From: Andrea Gordon [REDACTED]
Sent: 23 February 2021 11:05
To: NIEnquiries@planninginspectorate.gov.uk
Cc: Metrowest1 <Metrowest1@planninginspectorate.gov.uk>
Subject: Fwd: FAO MetroWest Phase 1 Case Team - Your Ref: TR040011

>>> I write regarding the above reference and what appears to be your revised proposal for Hayes Mays Lane. (HML), Pill.

>>> MetroWest Original Proposal for access to Pill Tunnel:

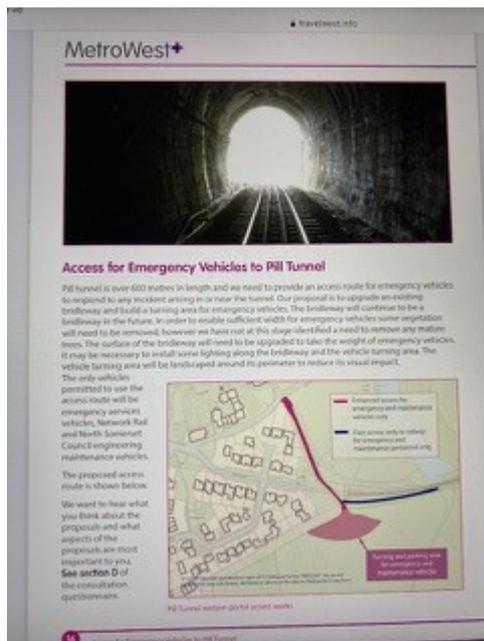
>>> I along with many of my neighbours attended your exhibition in 2015 where you advised >>> you would require access via Hayes Mays Lane to Pill Tunnel and a turning area at the bottom of the lane for vehicles for maintenance and emergencies. Access was also required at the other end of the tunnel at Watchouse Hill.

>>> Grasscrete was to be used at both areas especially Hayes Mays Lane as this is pure green belt an area of natural beauty full of wildlife and I enclose a copy of the proposal for your perusal at the end of my email.

>>> Photo of works completed at Watchouse Hill as agreed during the 2015 consultation:

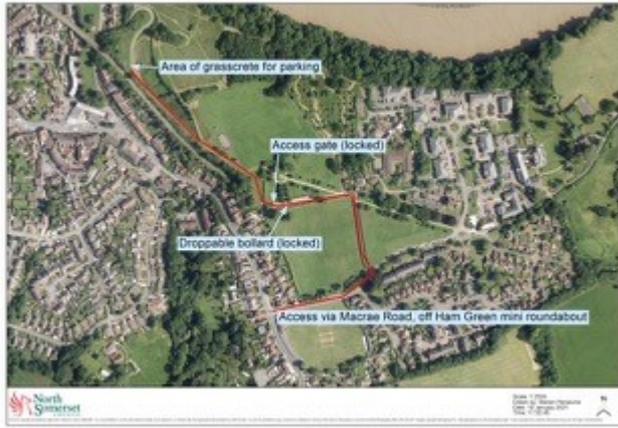
>>> Finally I enclose a picture of works completed at Watchouse Hill which confirms that MetroWest completed access as agreed at the 2015 consultation. The right hand side of the photo is Hayes Mays

Lane and as you can see a very beautiful environment where we would like to keep any impact to an absolute minimum and would urge MetroWest revert to their original plan.
